Case #: ZBA 2010-06
Date: March 1, 2010
Recommendation: Conditional Approval

PLANNING STAFF REPORT

Site: 47 Russell Road

Legal Notice: Applicants & Owners, Julia Lull & David Hayes, seek a Special Permit under SZO §4.4.1 to construct a dormer within the nonconforming side yard setback (8.5.H) and to expand the non-conforming floor area ratio (8.5.E).

45-47 Russell Road (l) left side of house, (r) right side of house

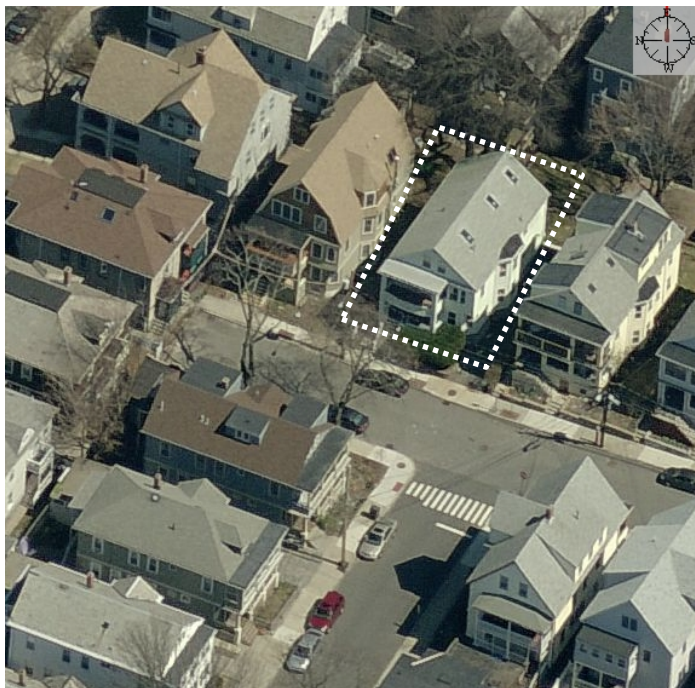
5. Impacts of Proposal: The current design would not have a negative impact on the appearance of the house. The dormer on the right side of the house would work with the bay window to add an interesting feature to the house. The turret would somewhat block the shed dormer behind it. Both of the shed dormers would start at the ridge; however, they would be set back slightly

from the main wall of the house. They would have several windows that relate to the windows on the rest of the house. There appears to be ten feet between the houses on either side so privacy issues are most likely not a concern.
